River District Design Commission

JUNE 14, 2018

A request has been filed for a Certificate of Appropriateness at the Craghead and Lynn Street Parking Area to install masonry walls and wooden gates. The masonry wall will be painted.

PLAN
Not to Scale

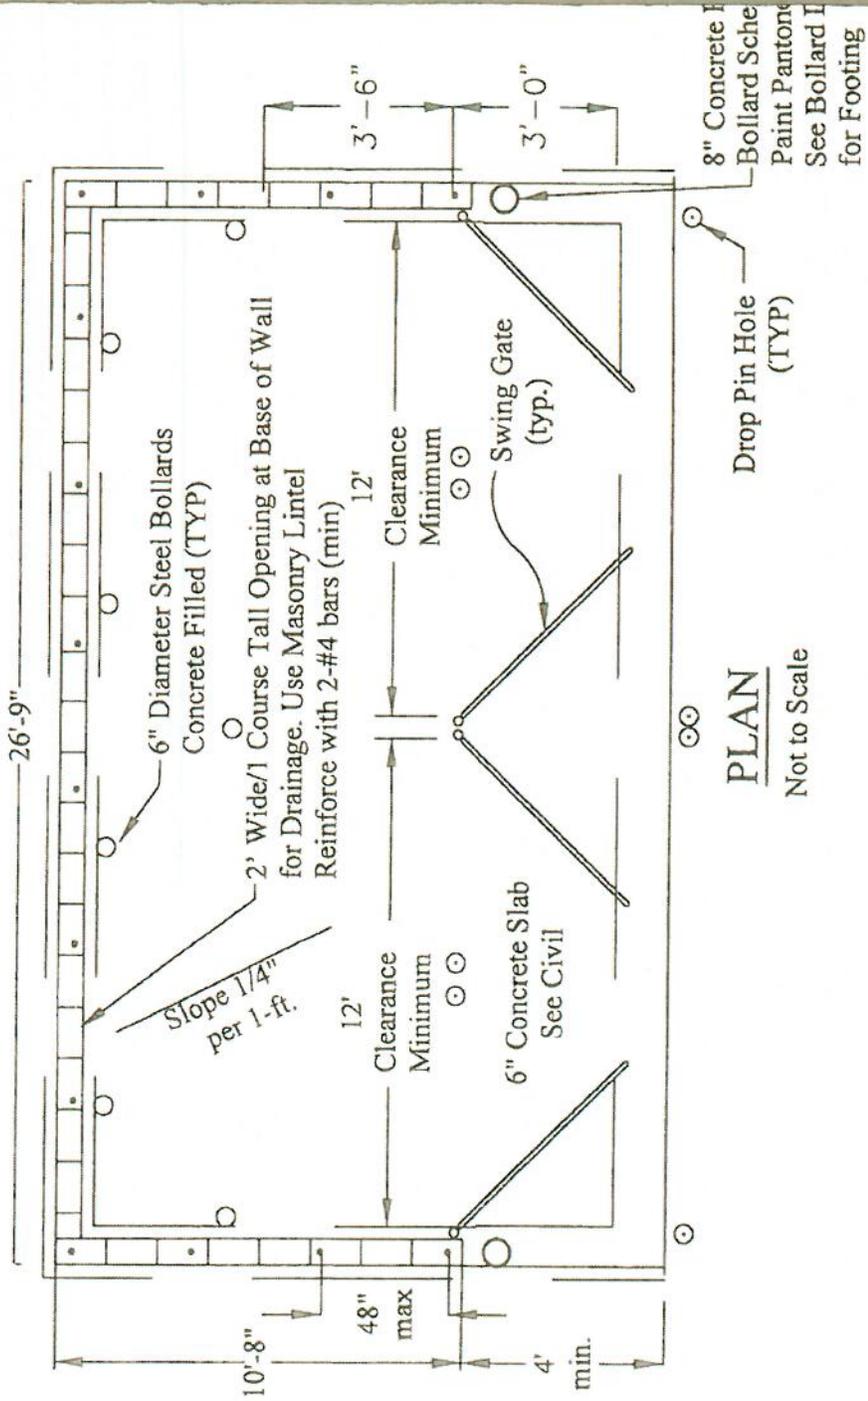
Work Proposed (please circle one): Alteration/addition/rehabilitation/new construction/sign **Craghead Dumpster Enclosure**
Install masonry walls and gates ~~with metal salts between chain link~~. The masonry wall will be painted.
made of wood (KG)

Staff recommends that the application be approved.
